- 6. Mallette Homestead Sub. No. 3  
KPB File 2023-001**

ITEM 6 – MALLETTE HOMESTEAD SUBDIVISION NO. 3

KPB File No.	2023-001
Plat Committee Meeting:	February 13, 2023
Applicant / Owner:	Dawn Mallette, Daniel and Jessica Rouggy all of Soldotna, Alaska
Surveyor:	Jason Schollenberg / Peninsula Surveying, LLC
General Location:	Sterling Highway, DJ's Drive, June Marie Street, Kalifornsky

STAFF REPORT

PENINSULA SURVEYING, LLC  
10535 KATRINA BOULEVARD, NINILCHIK, AK 99639  
(907)306-7065  
PLAT OF  
**MALLETTE HOMESTEAD SUBDIVISION  
NO. 3**

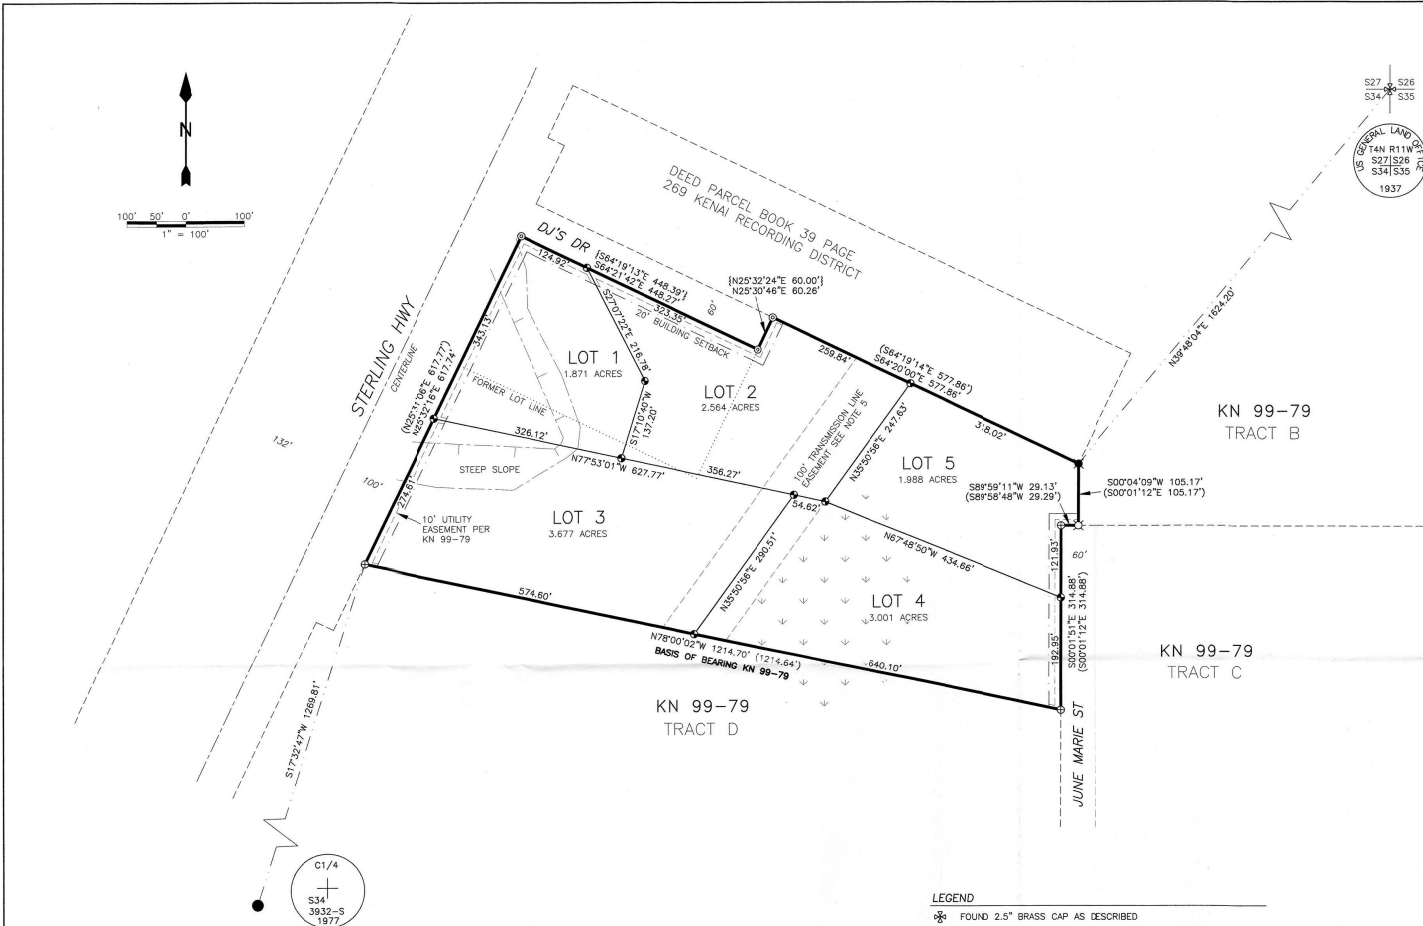
**Site Investigation:** The proposed plat has some low wet areas that will primarily be within proposed Lot 4. Looking at KPB GIS imagery, there may be an area of standing water present. **Staff recommends if open water is present to indicate as such or note if seasonal pond.**

There is some steep terrain present along the western portion of the subdivision within the area proposed for Lots 1 and 3. The terrain is depicted and **staff recommends the steep slopes remain on the final plat**. The location of the improvements and steep terrain on Lot 1 may limit the ability for replacement wastewater systems. The soils analysis report will indicate possible limitations that may impact the proposed design.

**Utility Easements** The parent plats granted the code required 10 foot utility easements adjacent to dedicated rights-of-way as well as increasing the width to 20 feet within 5 feet of the side lot lines. The preliminary plat is carrying those easements over correctly and is providing additional 20 feet within 5 feet of the new side lot lines. Any additional dedications required will be subject to the utility easement they should be depicted.

- Staff recommendation:** *Add "Alaska" to the location.*
- G. The status of adjacent lands within 100 feet of the proposed subdivision boundary or the land status across from any dedicated rights-of-way that adjoin the propose subdivision boundary, including names of subdivisions, lot lines, block numbers, lot numbers, rights-of-way; or an indication that the adjacent land is not subdivided;

- Staff recommendation:** *Provide the source for the Sterling Highway either within the depiction or reference a plat note.*
- J. Block and lot numbering per KPB 20.60.140, approximate dimensions and total numbers of proposed lots;

- Staff recommendation:** *Lot 1 is a portion of parent Lot 1. A different designation should be provided such as Lot 1A.*

- A. Street intersections shall be as nearly at right angles as possible, and no intersection shall be at an angle of less than 60 degrees. Where acute street intersections are designed, a minimum 50-foot radius corner at the right-of-way line of the acute angle shall be provided.
- B. Offset intersections are not allowed. The distance between intersection centerline shall be no less than 150 feet.
- C. Intersections of access streets with arterial streets or state maintained roads shall be limited to those intersections required for safe access consistent with KPB Title 14.
- D. Intersections of access streets with arterial streets or state maintained roads must be designed to the American Association of State Highway and Transportation Officials (AASHTO) standards.
- Staff recommendation:** *If continuations of DJ's Drive and June Marie Street are dedicated, comply with 20.30.150.*

*Within plat note 4 add "Misc" to the book description.*

**Staff recommendation:** comply with 20.60.200 Verify monuments found, monuments identified with a cross in a circle show a different pin per reference documents.
